UNITED STATES PATENT AND TRADEMARK OFFICE

10/562,024

Rudiger Briesewitz

Office Action Summary	Application No. 10/562,024	Applicant(s) BRISEWITZ ET AL.	
	Examiner MAHBUBUR RASHID	Art Unit 3657

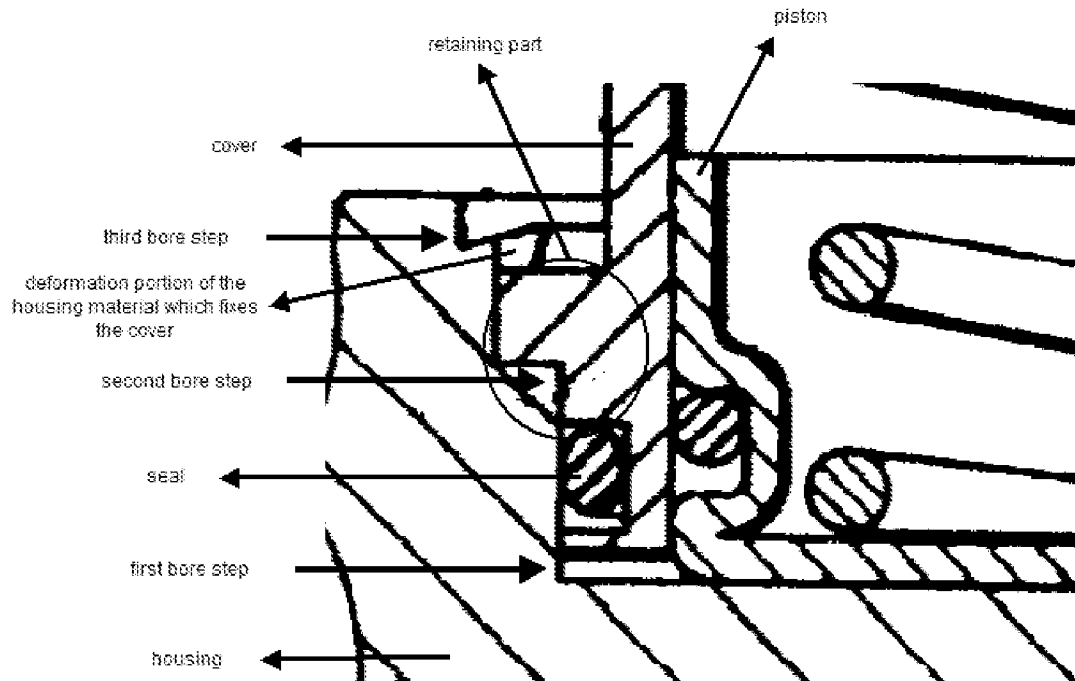
Regarding **claim 12**, Dinkel discloses a piston-type accumulator (fig. 7), with an axially movable piston (26) in a housing bore (1), with a seal (27) interposed between the piston (26) and the housing bore (1) and being fixed inside the housing bore (1), and with a cover (25) closing the end of the housing bore (1) which is designed as a stepped bore enlarged in diameter in which the seal (27) is fixed (see figure above).

Re-claim 13, see first and second bore steps, wherein the diameter of the first bore step corresponds to the inside diameter of the housing bore (1), while the inside

diameter of the second bore step is adapted to the outside diameter of the seal (see figure above).

Re-claim 14, see a third bore step which is formed by a plastic deformation of the housing material which fixes the cover at the stepped bore (see figure above).

Re-claims 15-16, see a retaining part ((28); see also the figure above) bears directly against the second bore step and wherein the seal (27) is covered by the retaining part.

Re-claim 20, see the edge (28) of the cover (25) is bent off at right angles in an outward direction in order to provide the contour of an annular washer and is covered outside by the third bore step (see figure above).
